Access Compliance Report

Public Rights-of-Way

Intersection ID: 10018704	Main Street: HERONS_POND_CT	Cross Street: N/A	Location: E
ADA ID: 193383B379A9	Ramp Type: Perp	Initial Pass/Fail: Fail	Overall Compliance: No
		Severity Score: 22.5

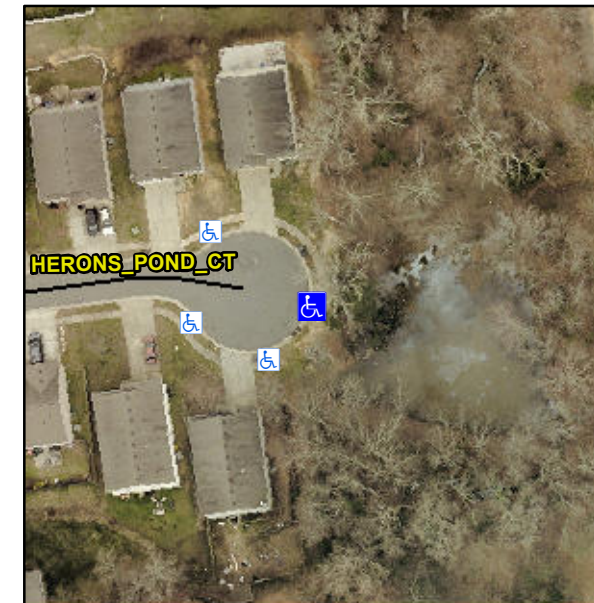
Not Found, R304.5.1, R304.2.2, R304.5.3

Compliance	Description	Data	Compliance	Description	Data
N/A	Ramp Length (in)	52.0	No	Ramp Slope (%)	8.7
No	Ramp Width (in)	45.5	No	Ramp XSlope (%)	2.6
N/A	Flare Type LT	N/A	N/A	Flare Type RT	N/A
N/A	Flare Slope LT (%)	N/A	N/A	Flare Slope RT (%)	N/A
N/A	Flare Traversable LT?	N/A	N/A	Flare Traversable RT?	N/A
N/A	Landing Length (in)	N/A	N/A	DWS Provided?	N/A
N/A	Landing Width (in)	N/A	N/A	DWS Contrast?	N/A
N/A	Landing Slope (%)	N/A	N/A	DWS Length (in)	N/A
N/A	Landing X Slope (%)	N/A	N/A	DWS Full Width?	N/A
N/A	Landing Curb? (Y/N)	N/A	N/A	DWS Offset (in)	N/A
N/A	Shared Landing?	N/A			
N/A	Gutter Ponding?	N/A	N/A	Gutter Slope (%)	N/A
N/A	Gutter Lip Ht (in)	N/A	N/A	Gutter X Slope (%)	N/A
N/A	Painted X Walk1?	No	N/A	Painted X Walk2?	N/A
	X Walk 1 Direction	To W		X Walk 2 Direction	N/A
N/A	X Walk 1 Width (in)	N/A	N/A	X Walk 2 Width (in)	N/A
	X Walk 1 Slope (%)	2.5		X Walk 2 Slope (%)	N/A
	X Walk 1 X Slope (%)	1.4		X Walk 2 X Slope (%)	N/A

Remove & Replace Entire Ramp.
